Re: PETITION NO. 1353 - The United Illuminating Company petition for a declaratory ruling pursuant to Connecticut General Statutes §4-176 and §16-50k for the proposed modifications to the existing Seaview Tap Substation located at 1677 Seaview Avenue, Bridgeport, Connecticut.

Enclosed please find the original and fifteen (15) copies of The United Illuminating Company's responses to the Siting Council's First Set of Interrogatories dated October 26, 2018 in connection with the above-referenced petition.

The United Illuminating Company
Petition No. 1353

Figure #1

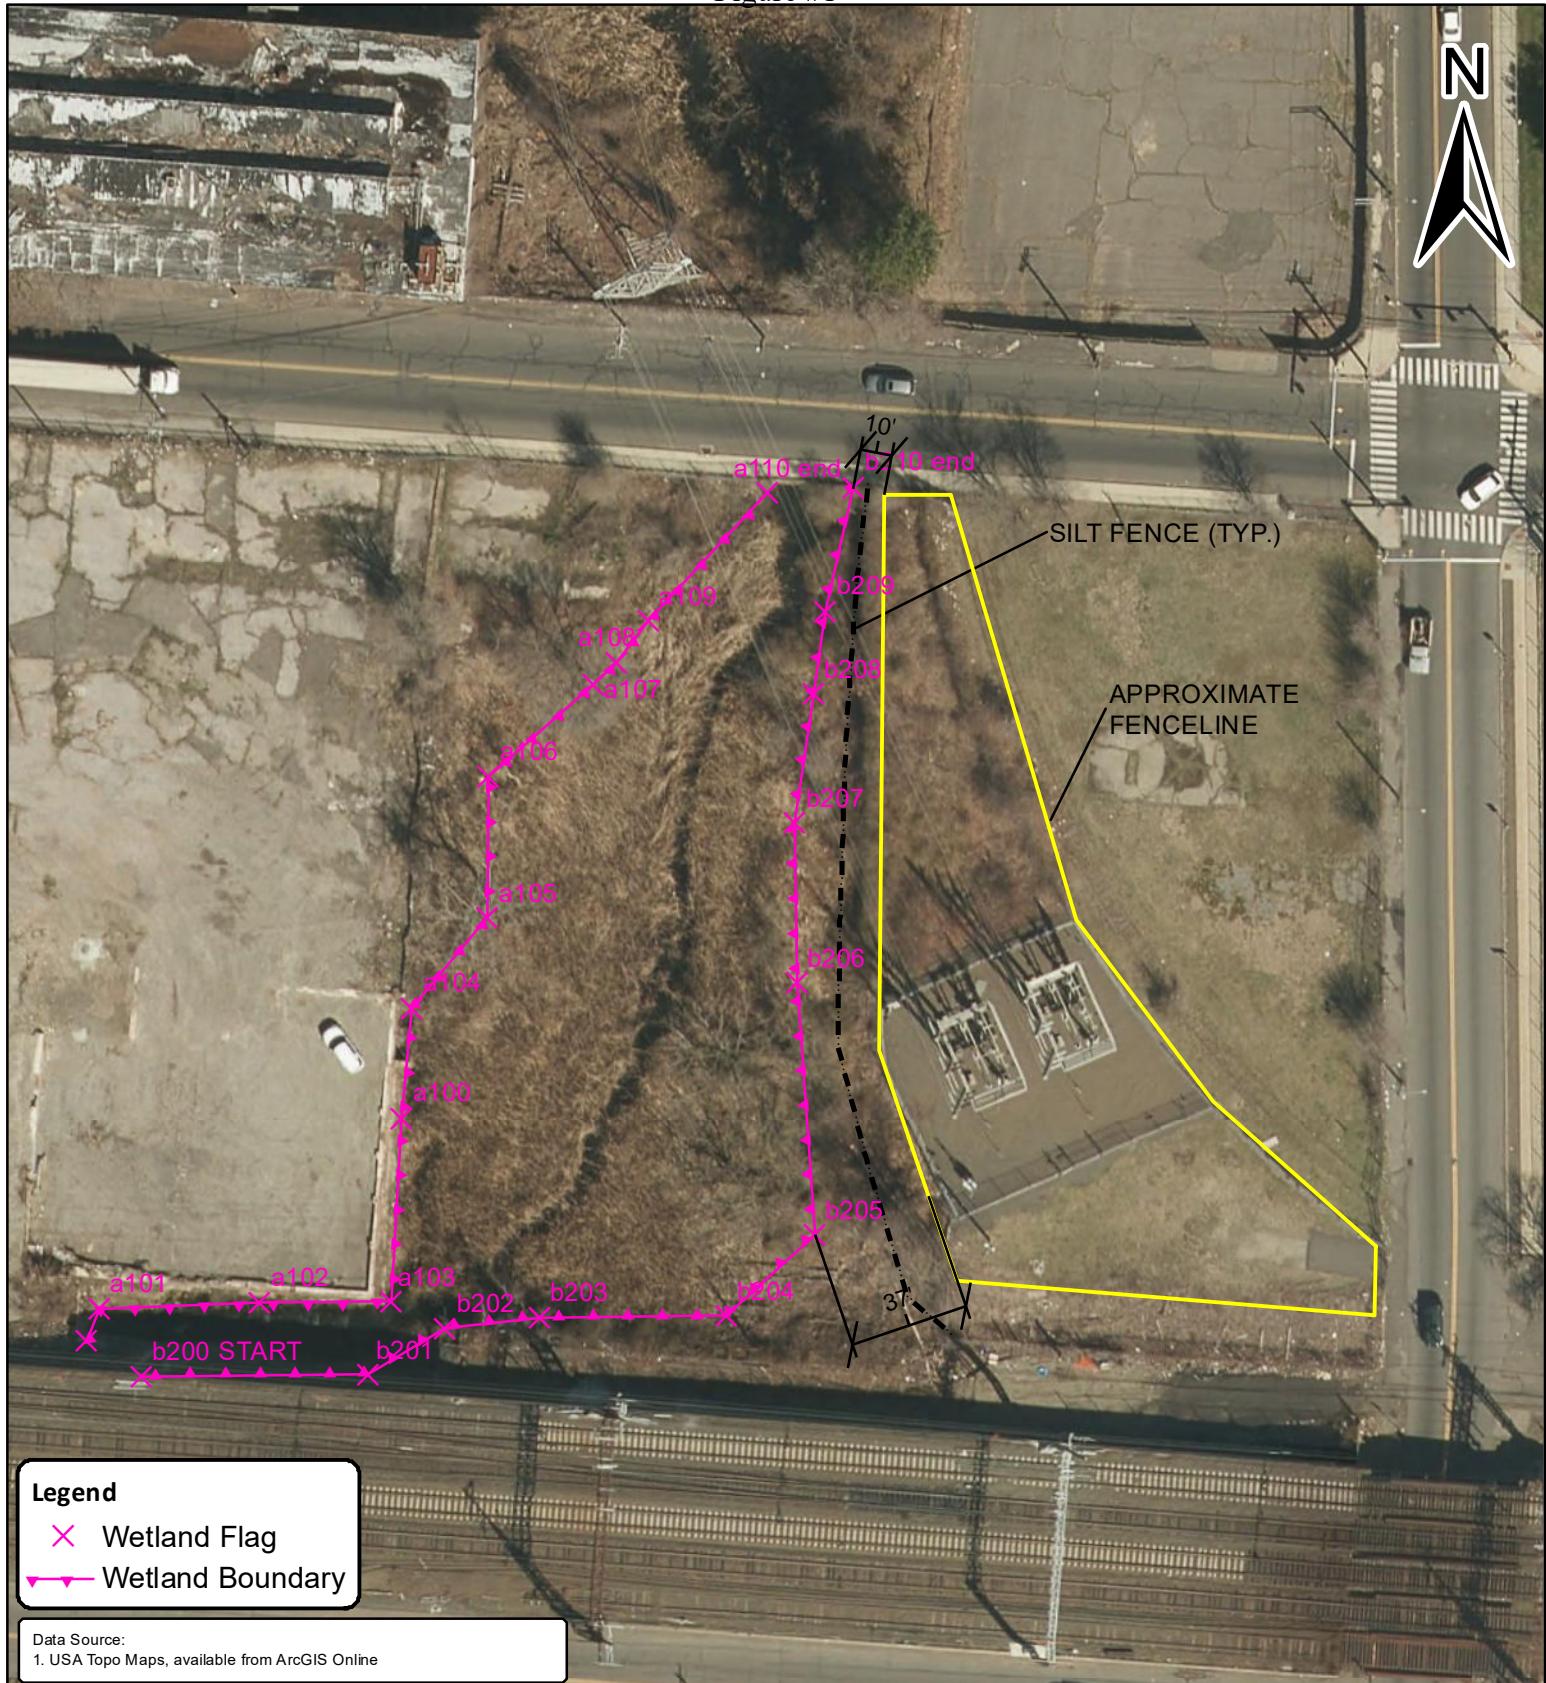
Q-CSC-I-9: Provide the distance and direction from the work area to the nearest wetland/watercourse. Would the proposed erosion and sediment (E&S) controls (noted on page 10 of the Petition) protect adjacent wetlands/watercourses? Provide a drawing depicting the wetland/watercourse locations relative to the proposed project and the locations of the proposed E&S controls.

A-CSC-I-9: See Figure #1 which shows the location of the flagged wetlands, the existing fence line and the proposed E&S controls (silt fence) for the project.

Yes the proposed E&S controls will protect adjacent wetlands and watercourses.

There are no proposed activities inside the wetlands.
